Access Compliance Report

Public Rights-of-Way

(Island Curb Cuts)

Intersection ID: 3559	Main Street: PERIMETER_PY	Cross Street: W_W_T_HARRIS_BV	Location: NE
ADA ID: 0B259B2538E3	Curb Cut Type: IslandRefuge3	Initial Pass/Fail: Fail	Overall Compliance: No
		Severity Score: 36.25

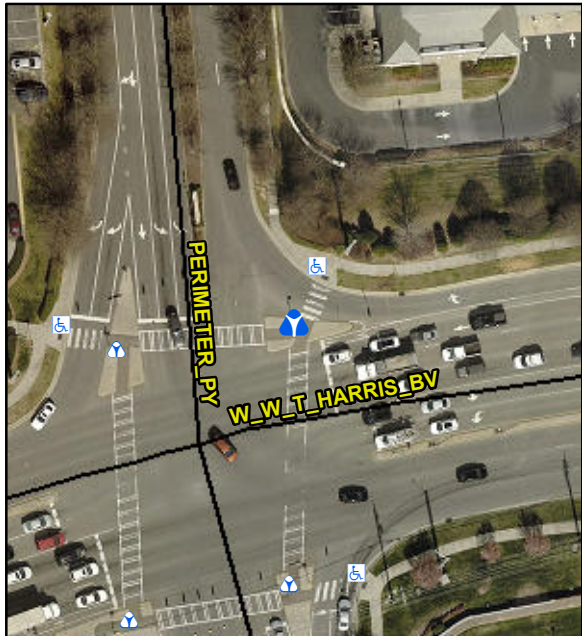
Codes/Mitigation Info/Possible Solution			Field Measurements/Component Compliance						
	Possible Solutions:		Compliance	Description	Data	Compliance	Description	Data	
	Remove & Replace Entire Refuge.		Yes	Refuge 1 Length (In)	178.0	N/A	Gutter 1 Ponding?	N/A	
			Yes	Refuge 1 Width (In)	72.0	N/A	Gutter 1 Lip Ht (In)	N/A	
			Yes	Refuge 1 Slope (%)	2.5	N/A	Gutter 1 Slope (%)	N/A	
			Yes	Refuge 1 X Slope (%)	0.3	N/A	Gutter 1 X Slope (%)	N/A	
			N/A	Painted X Walk1?	Yes	N/A	DWS 1 Provided?	N/A	
	Surveyor Notes:		N/A	X Walk 1 Direction	To W	N/A	DWS 1 Contrast?	N/A	
		N/A		N/A	X Walk 1 Width (In)	120.0	N/A	DWS 1 Length (In)	N/A
				N/A	Road 1 Slope (%)	0.1	N/A	DWS 1 Full Width?	N/A
				N/A	Road 1 X Slope (%)	3.0	N/A	DWS 1 Offset (In)	N/A
PROW/ADA:				Yes	Refuge 2 Length (In)	61.0	N/A	Gutter 2 Ponding?	N/A
			Yes	Refuge 2 Width (In)	78.0	N/A	Gutter 2 Lip Ht (In)	N/A	
		Yes	Refuge 2 Slope (%)	0.6	N/A	Gutter 2 Slope (%)	N/A

Yes	Refuge 2 X Slope (%)	4.3	N/A	Gutter 2 X Slope (%)	N/A		
		N/A	Painted X Walk2?	Yes	N/A	DWS 2 Provided?	N/A		
		N/A	X Walk 2 Direction	To S	N/A	DWS 2 Contrast?	N/A		
		N/A	X Walk 2 Width (In)	110.0	N/A	DWS 2 Length (In)	N/A		
		N/A	Road 2 Slope (%)	2.2	N/A	DWS 2 Full Width?	N/A		
		N/A	Road 2 X Slope (%)	2.5	N/A	DWS 2 Offset (In)	N/A		
			Yes	Refuge 3 Length (in)	45.0	N/A	Gutter 3 Ponding?	N/A	
		Yes	Refuge 3 Width (in)	72.0	N/A	Gutter 3 Lip Ht (in)	N/A		
		Yes	Refuge 3 Slope (%)	1.1	N/A	Gutter 3 Slope (%)	N/A		
		Yes	Refuge 3 XSlope (%)	3.8	N/A	Gutter 3 XSlope (%)	N/A		
		N/A	Painted X Walk3?	Yes	N/A	DWS 3 Provided?	N/A		
		N/A	X Walk 3 Direction	To NE	N/A	DWS 3 Contrast?	N/A		
		N/A	X Walk 3 Width (in)	118.0	N/A	DWS 3 Length (in)	N/A		
		N/A	Road 3 Slope (%)	2.1	N/A	DWS 3 Full Width?	N/A		
		N/A	Road 3 XSlope (%)	0.9	N/A	DWS 3 Offset (in)	N/A		
		Yes	Any Obstructions?	N/A	N/A	Storm Grate/Utility Hazard?	N/A
